Safety Recall

Code: 74E3

REVISION

Subject Passenger Occupant Detection System (PODS)

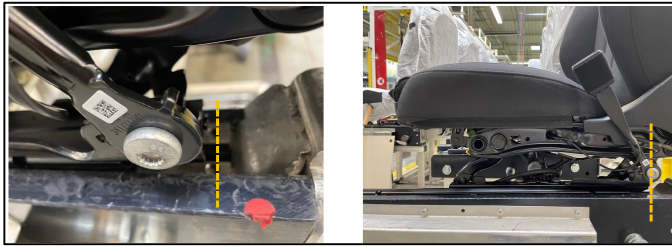
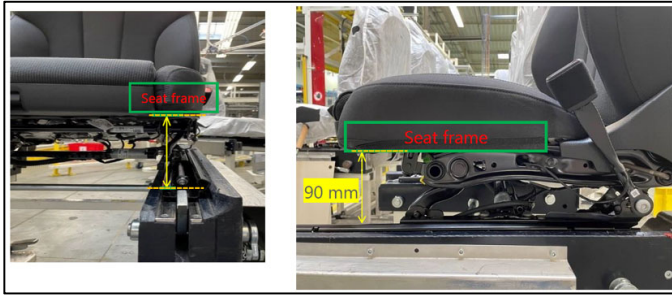
REVISION SUMMARY Added instructions in Section C and Appendix A in the event fault B1022F0 does not clear

If the PODS basic setting test plan is successful, and fault B1022F0 returns when exiting ODIS, the following steps will aid in getting the fault to clear.

- Adjust the front passenger seat as described in the following steps.
- Ensure the 12V battery maintainer is installed.
- After all adjustments have been made, run the test plan for the B1022F0 fault. The test plan will re-populate the PODS basic setting test plan.
- If the B1022F0 returns again after completing the PODS basic setting test plan, minor adjustments may need to be made to the seat backrest position or the seat front/back position.
- Set backrest angle to approximately 81°.

- Set seat height to 50 mm.
- The measurement is taken at the lower edge of the 4 corner hole to the highest point of the outer seat rail.

- Seat seat bottom angle by adjusting the front of the seat frame height to 90 mm.
- The measurement is taken at the lower edge of the seat shell to the lowest point of the outer seat rail.
